Item 13: Jones Creek Regional Planning Group Project Independent Review

Date: February 2, 2015
To: Board of Directors
From: Jeff Billo, Manager, Transmission Planning
Subject: Jones Creek Regional Planning Group Project Independent Review

ERCOT Independent Review of the CenterPoint Jones Creek Project

Figure 1: Area of Concern

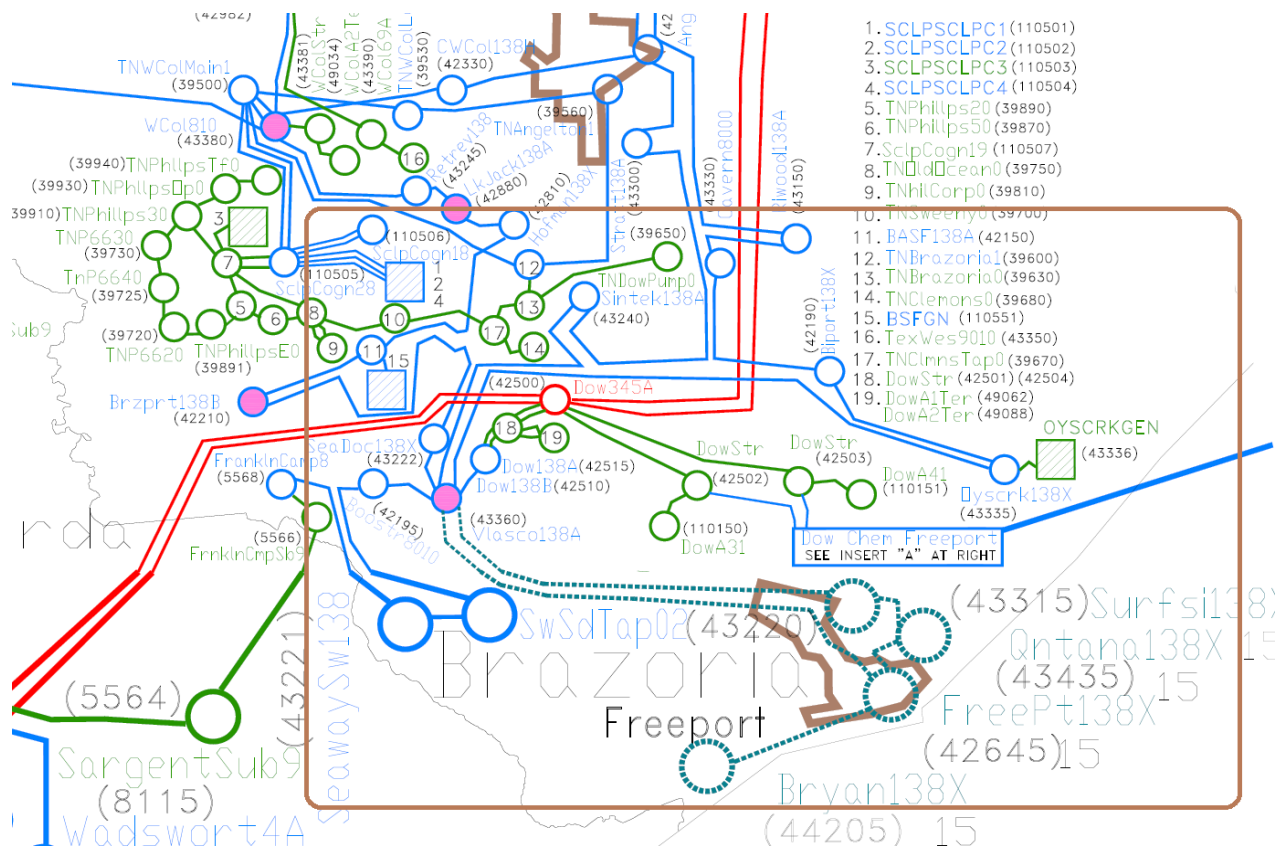
With the above load addition and using the 2019 summer peak load case, under the X-1+N-1 contingencies when both of Dow–Velasco 345/138 kV autotransformers are out of service the case does not solve, which indicates a system voltage collapse. Additionally, several thermal violations around the Freeport area can be observed under certain N-1 or X-1+N-1 contingencies. Figure 1 shows the area of concern.

In conclusion, ERCOT recommends the following transmission upgrades studied as Option B, which constitute the most effective solution to serve the projected load growth in the Freeport area:
